OBJECTIVE: EVALUATE CHANGE IN GIRDER PROPOSED IN RFI 459.

For INNERBELT RFI 459

Job no. 49633

SKETCH: SEE ALSO ATTACHED SHOP DRAWINGS

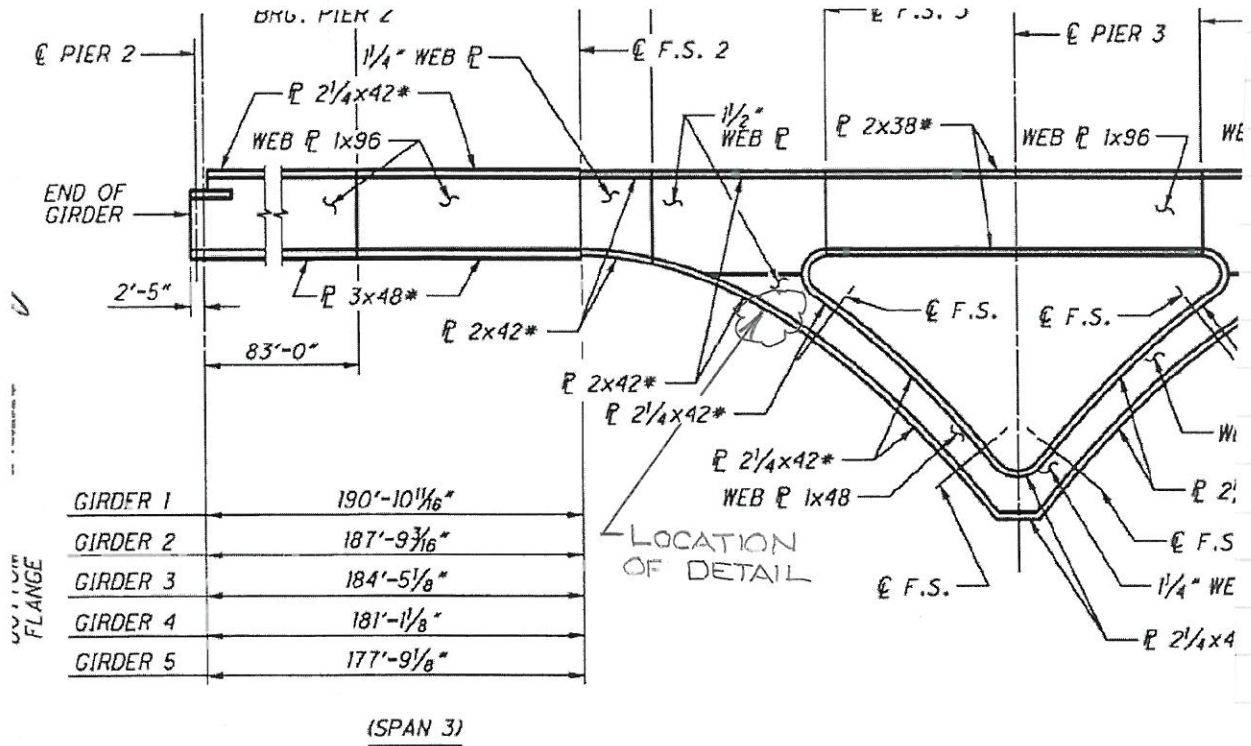
THE FLANGE IS PRIMARILY IN COMPRESSION. THE LARGER HOLES WILL NOT AFFECT THE COMPRESSION CAPACITY OF THE FLANGE.

CHECK TENSILE CAPACITY OF THE FLANGE:

$$\text{YIELD OF GROSS SECTION} = \phi_y * F_y * A_g = 0.95 * 70 \text{ ksc} * 2" * 42" = 5586 \text{ k}$$

$$\text{FRACTURE OF NET SECTION} = \phi_u * F_u * A_n = 0.80 * 85 \text{ ksc} * 2" * (42" - 4 * \frac{13}{16}) = 5270 \text{ k} < 5586 \text{ k}$$

⇒ FRACTURE CONTROLS

$$\text{MAX. TENSILE STRESS IN BOT. FLG.} = 7.02 \text{ ksc}$$

$$\text{MAX. TENSILE FORCE IN BOT. FLG.} = 7.02 \text{ ksc} * 2" * 42" = 590 \text{ k} < 5270 \text{ k } \phi_k$$

CHECK EDGE DISTANCE:  $21'' - 19.5'' = 1.5'' = 1.25'' + 0.25'' = \text{MIN. EDGE DISTANCE}$   
FOR  $\frac{3}{4}'' \varnothing$  BOLT IN  
PLATE W/  
SHEARED EDGE.

FATIGUE CATEGORY DOES NOT CHANGE, NO NEED TO CHECK.

RESULT: CHANGE PROPOSED IN RFI 459 IS ACCEPTABLE.  
 $\frac{5}{8}'' \varnothing$  BOLT MAY BE USED PROVIDED A HARDENED  
WASHER IS INSTALLED OVER THE  $\frac{13}{16}'' \varnothing$  HOLE.  
OTHERWISE, A  $\frac{3}{4}''$  BOLT SHALL BE INSTALLED.
